## **RESPONSE TO COMMENTS**

A period for public comments on the Draft Supplemental Environmental Impact Report (DSEIR) for the Chinese Bible Church took place from August 24, 2017 to October 29, 2017. All comments received during this period, and the County's responses to those comments are provided in this section. The section has three parts: (1) a List of Persons, Organizations and Public Agencies That Commented on the Draft EIR; (2) four general responses on the subjects of land use and planning, biology, traffic, parking and queuing, and visual effects; and (3) the comments and responses texts.

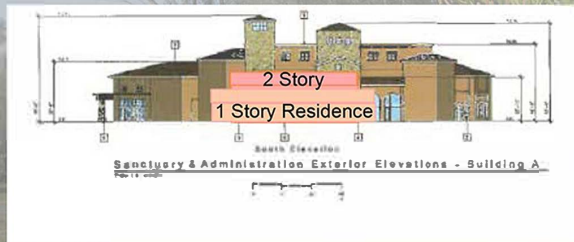
Proposed	Type	Adjacent	Compatible?
Church	Civic	No	No
Pre-school	Civic	No	No
Café	Commercial	No	No
Bookstore	Commercial	No	No
Residence	Residential	Yes	No
All of the above	All	No	No

▢ There are no other properties in the SFVSP that comprise a combination of commercial, residential and civic uses  
▢ All other civic uses serve the entire community

**O-5-11** .The comment provides a land use table and notes the proposed use is incompatible with existing uses. Column 3 ignores the fire station, which is an adjacent civic use. The table shows the proposed uses to be church, pre-school, café, bookstore, and residence. No pre-school or residences are proposed by the project. The café and bookstore are ancillary to and are in support of the church function, and are not as such commercial uses such as would be found in Black Mountain Ranch North Village located approximately 550 feet to the southwest. Sleeping accommodations will be provide for congregants who will remain at the facility for days up to a few weeks while they undertake Bible study or participate in symposia or missionary training. These will be guests and the stays will fall within the scope of transient occupation in conformance with County regulations. Column 4 of the table indicates none of the proposed uses are compatible with adjacent uses. Reasoning is not provided so a detailed response is not possible. However, churches are generally considered to be compatible with residential and other civic uses. The comment states there are no other properties that represent a combination of these uses within the SFVSP. The statement provides no specific reasoning as to why this is an undesirable use. Additionally, mixed use is a common use type in the area. These include Maranatha Church, Del Norte High School, and Design 39 School, among others. The comment also states all other uses serve the entire community. This is a subjective statement unsupported by facts. It is not an exaggeration to say that schools, churches, and medical facilities, to name a few, serve the entire communities in which they are located. The project is being sponsored by the Chinese Bible Church of San Diego which is an open church that welcomes visitors and new members alike. The church has stated its café and bookstore, as well as its services, will be open to all.
